April 30, 2010

Re: Important Notice – Mandatory fuel shut-off valve upgrade
Bulletin Number: W1-SL-002
Recall Number 10V-165

Figure 1: Manual shut-off valve must remain open

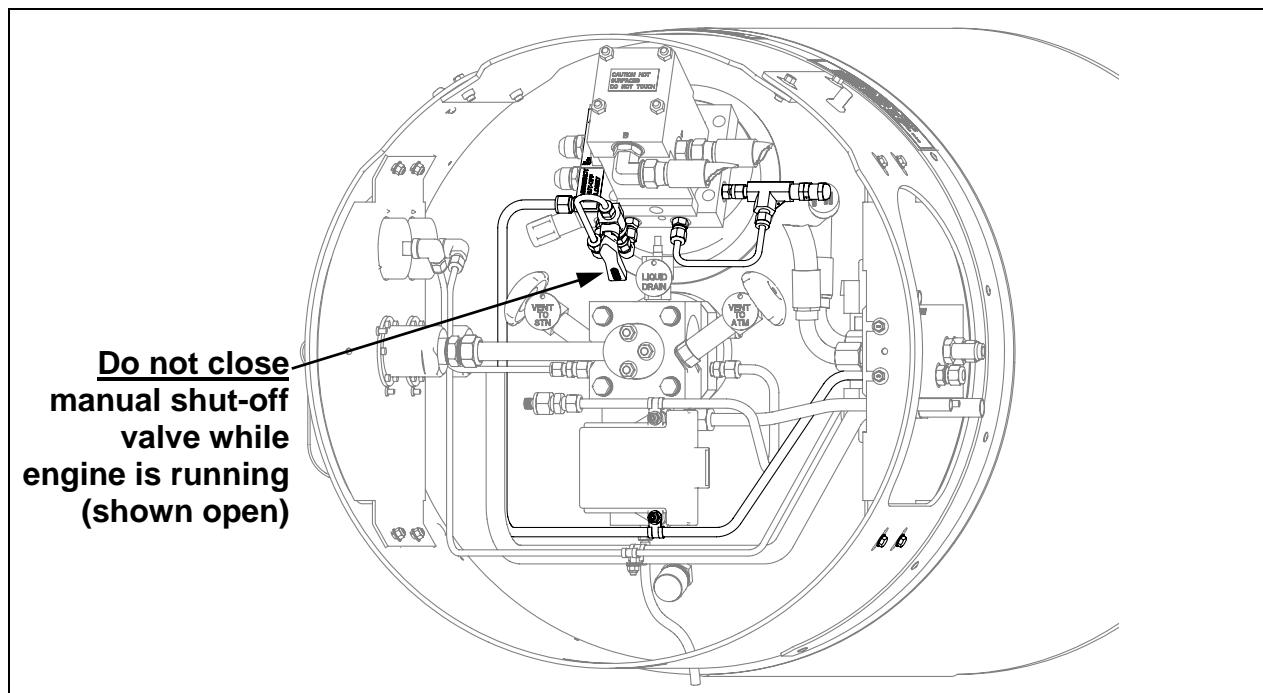
A vent hole associated with the pump pressure relief valve may have been covered by a welding process, during the manufacture of the pump. This can render the pressure relief valve ineffective, resulting in the possible build up of gas in the pump if the manual shut-off valve is closed. This could result in a sudden leak of high pressure gas within the tank shroud and a slower leak of tank pressure, which could result in personal injury and/or vehicle or property damage.

As described in the Operator's Manual, the manual shut-off valve is open during normal truck operation, and as such you do not need to do anything different during normal vehicle operations. However, it is important to never close the manual shut-off valve while the engine is running as outlined in your ISX G and LNG System Operator's Manual. Please ensure that the manual shutoff valve is open at all times, see Figure 1.

Westport HD will inspect and correct the problem by upgrading to an automatic shut-off valve that does not use the vent hole. The labor time necessary to perform the inspection and service will be approximately 2 hours. Should repair be required, additional time may be necessary. The work will be performed for you at no charge.
